Addendum #4

East Lake Community Center Renovations

CONTRACT NO. Y-17-005

E2.0
 LIGHTING PLAN

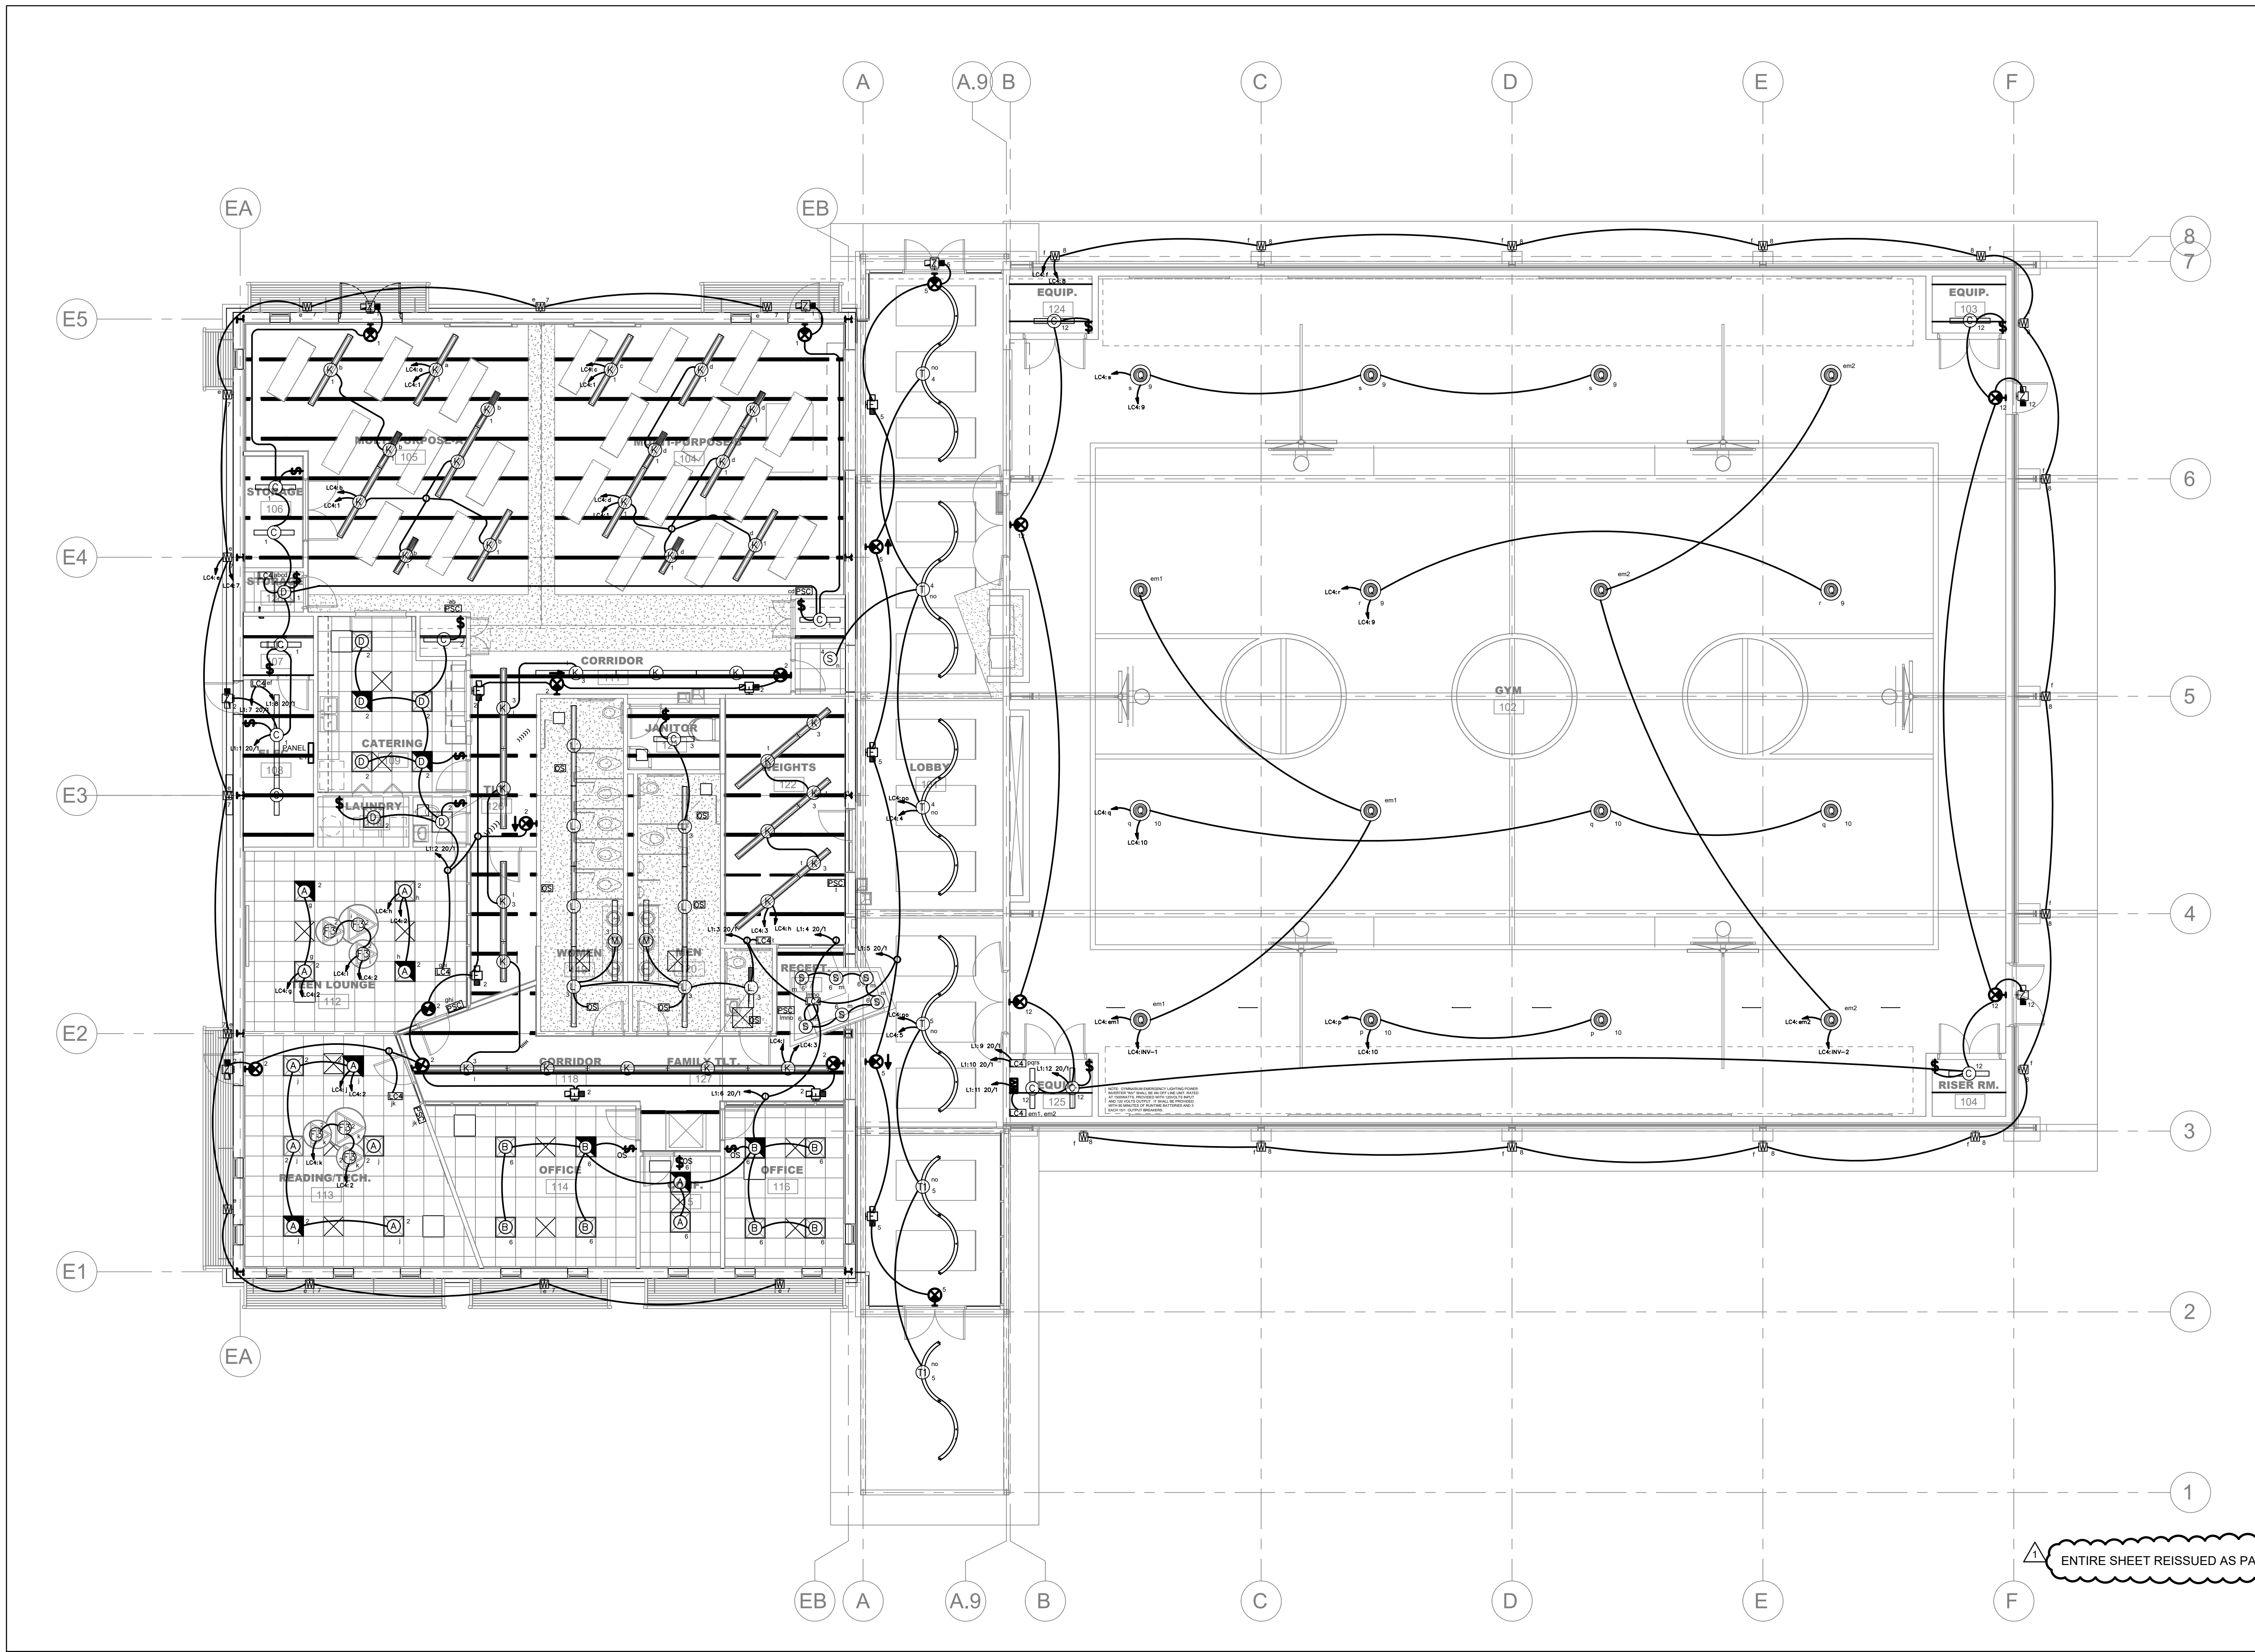
- Sheet is extensively modified with the addition of circuitry and panel designations and is replaced in its entirety.

E5.0
 AUXILIARY PLAN

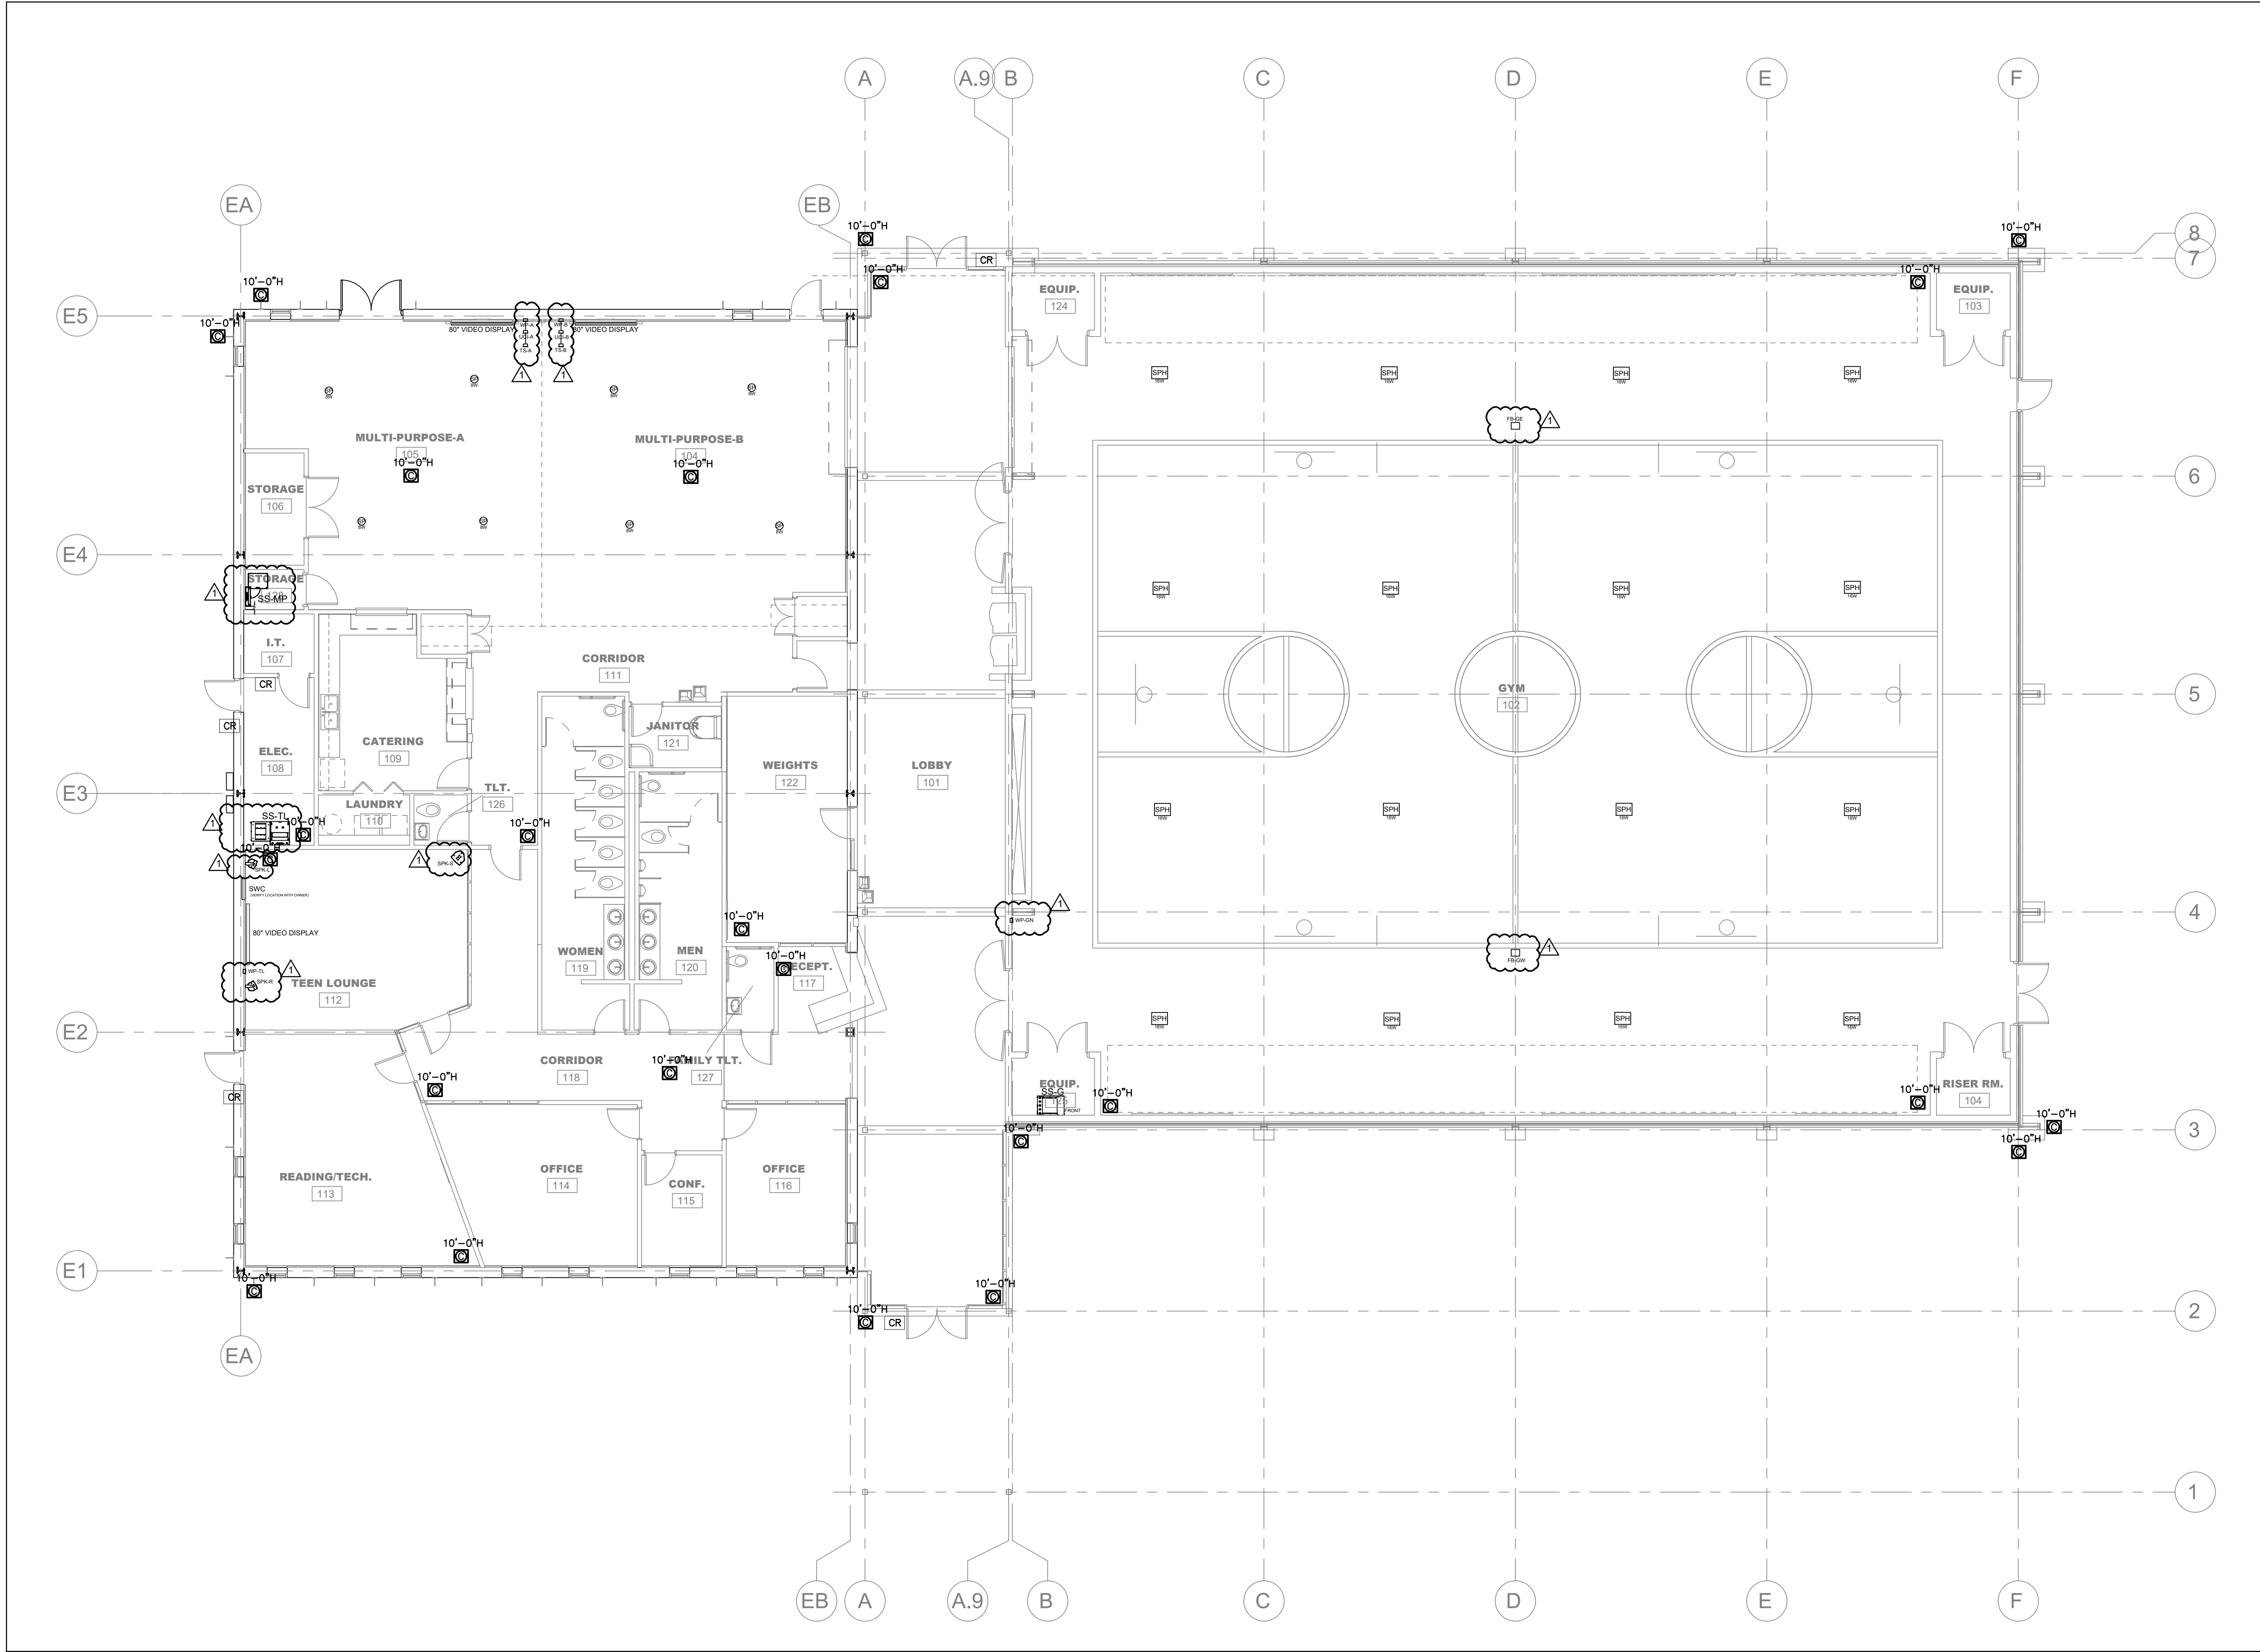
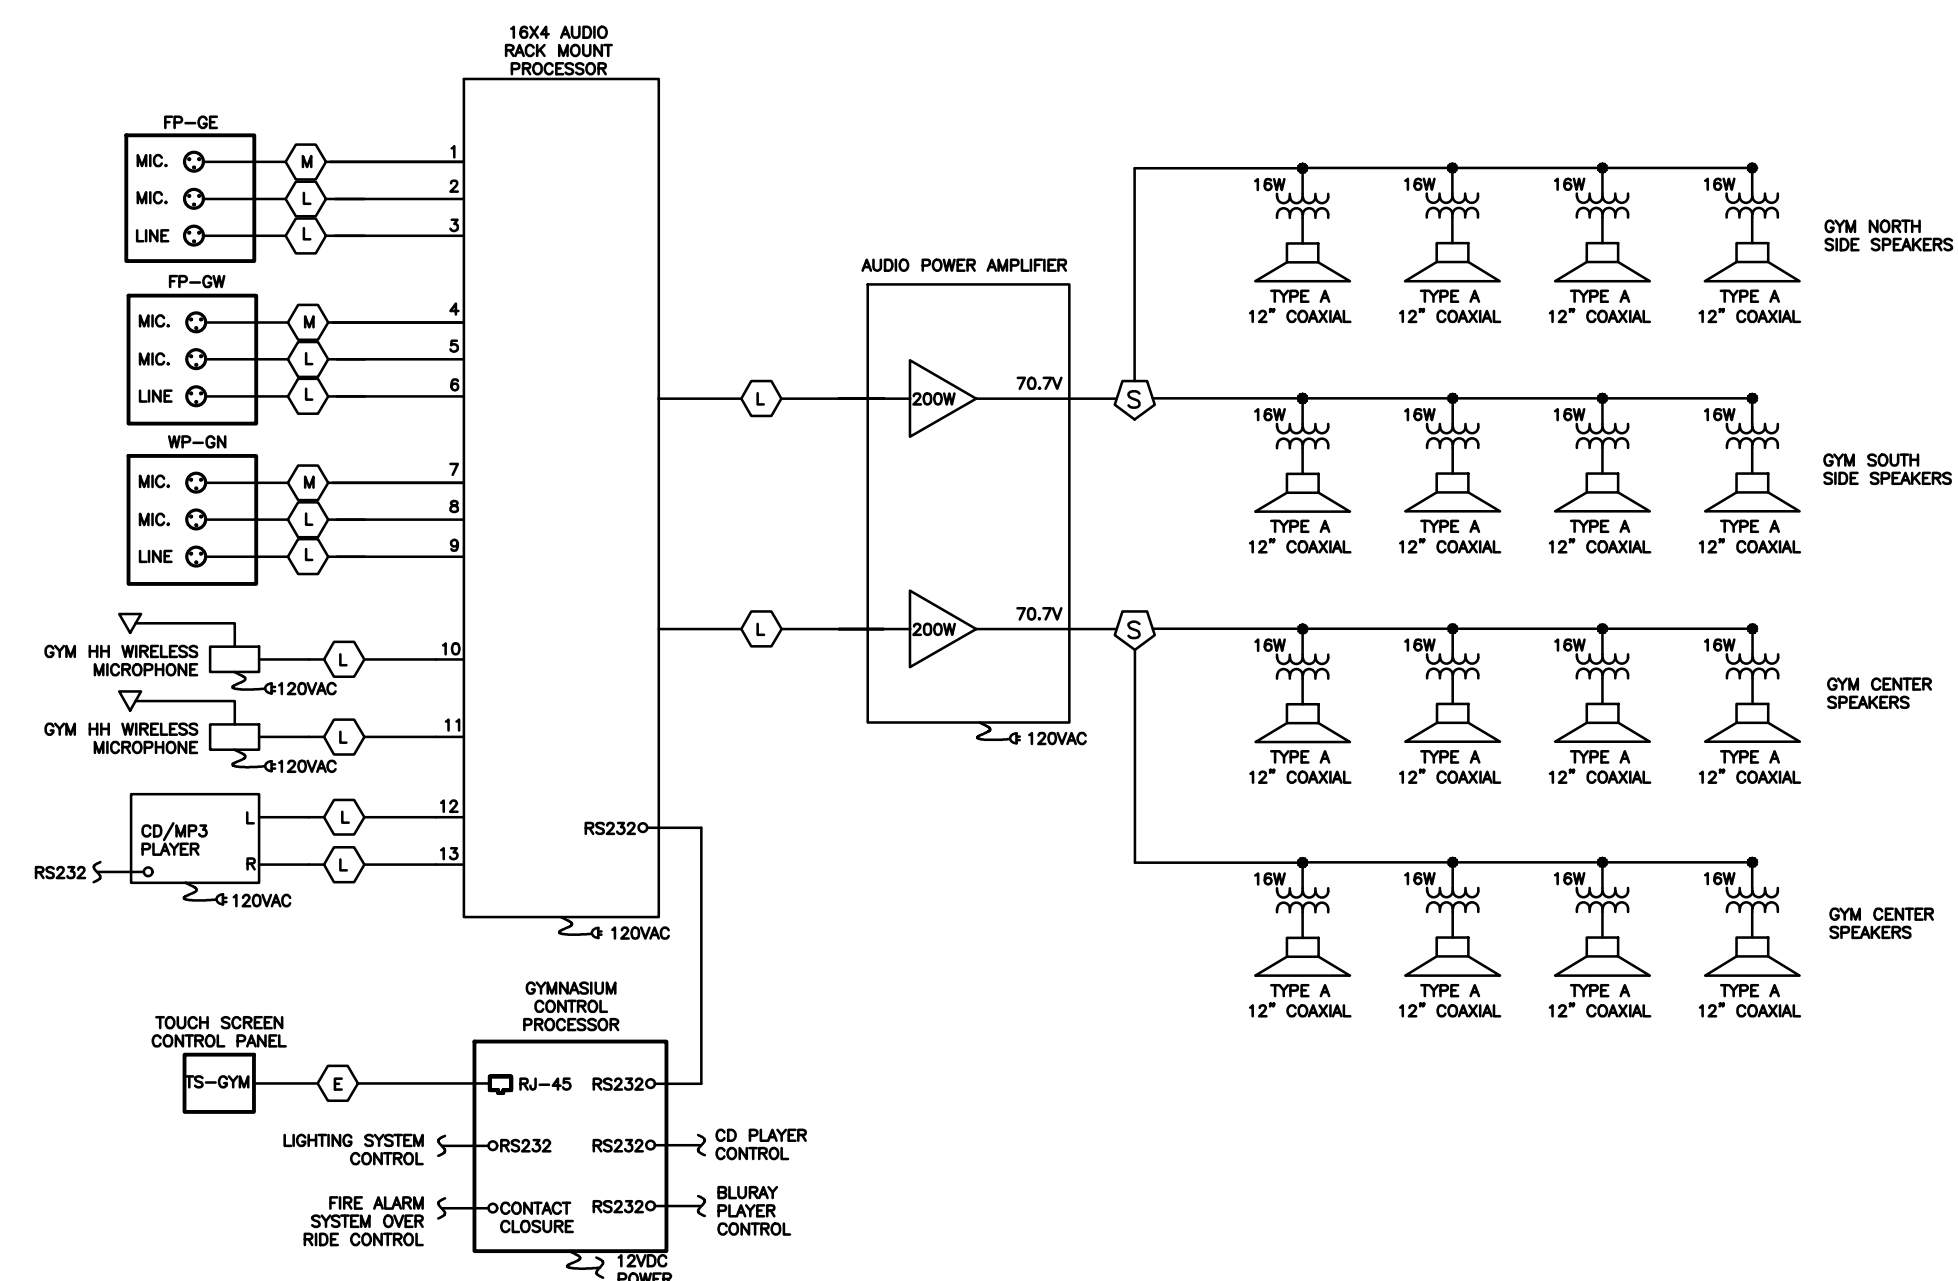
- Clarified Symbols for two equipment racks, added symbols for AV input equipment devices. Modified speaker layout in Teen Lounge.
